SUSITNA HYDROELECTRIC PROJECT

(PROJECT NO. 7114-000)

RESPONSES TO AGENCY COMMENTS ON LICENSE APPLICATION

January 19, 1984

Figure B.39.1

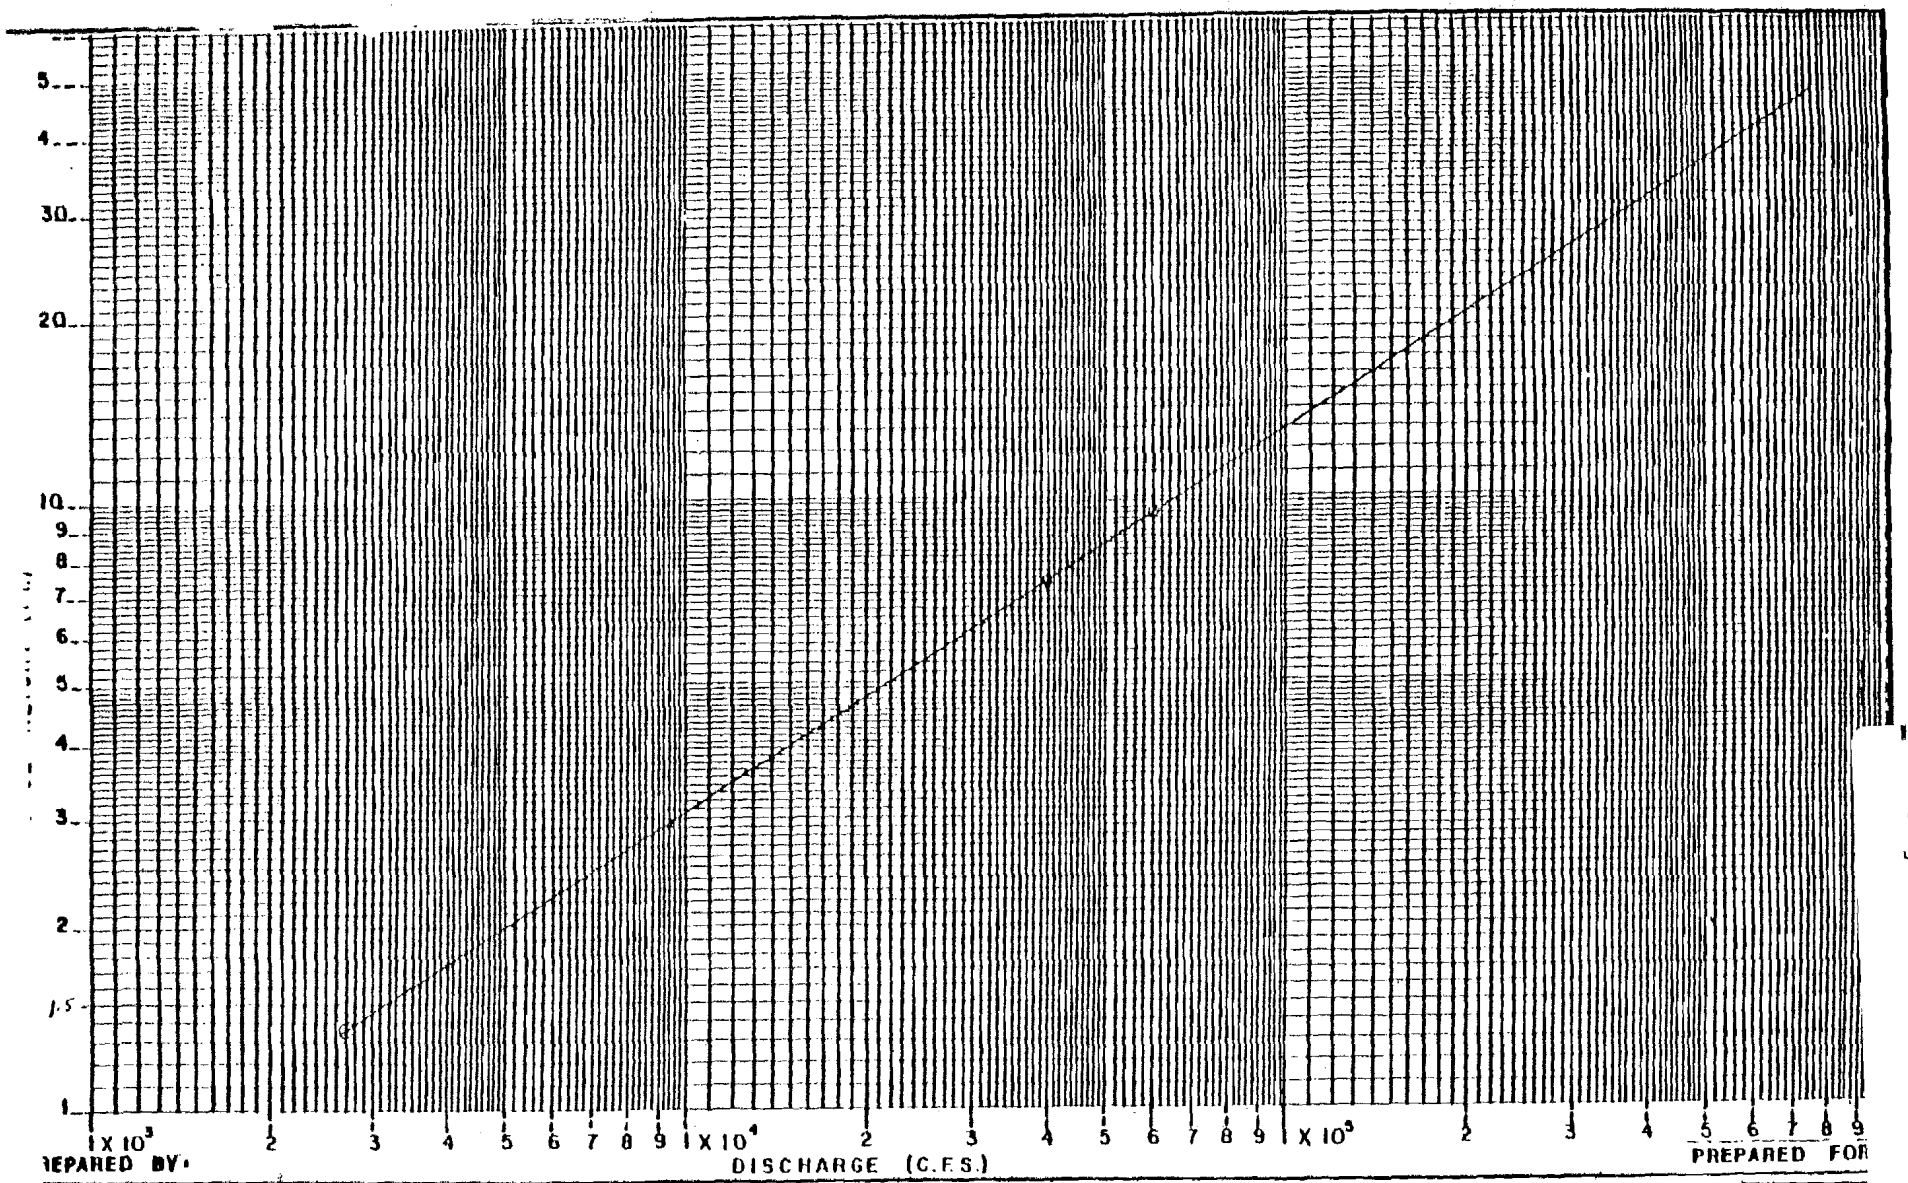
"The statement that (flow) reductions less than 10 percent are not expected to impact fish is not supported in the absence of any data regarding habitat value changes with incremental flow. Significant flow changes will exist in the lower river for at least seven months of the year."

Further analysis using discharge rating curves (R&M Consultants, Figure B.39.1; USGS, Table B.39.2) indicates that a 10 percent reduction in the mean monthly average flows (13,966 cfs reduced to 12,570 cfs) translates to a water surface elevation change of approximately 0.25 feet or 3 inches. Similarly, a 10 percent reduction of the highest recorded monthly average flow (18,555 cfs reduced to 16,700 cfs) translates to a water surface elevation change of approximately 0.3 feet or 3.6 inches and a 10 percent reduction of the minimum recorded monthly average flow (9,416 cfs reduced to 8,475 cfs) translates to a water surface elevation change of approximately 0.2 feet or 2.5 inches. A similar analysis can be performed for other months in which decreases will be expected with somewhat similar results.
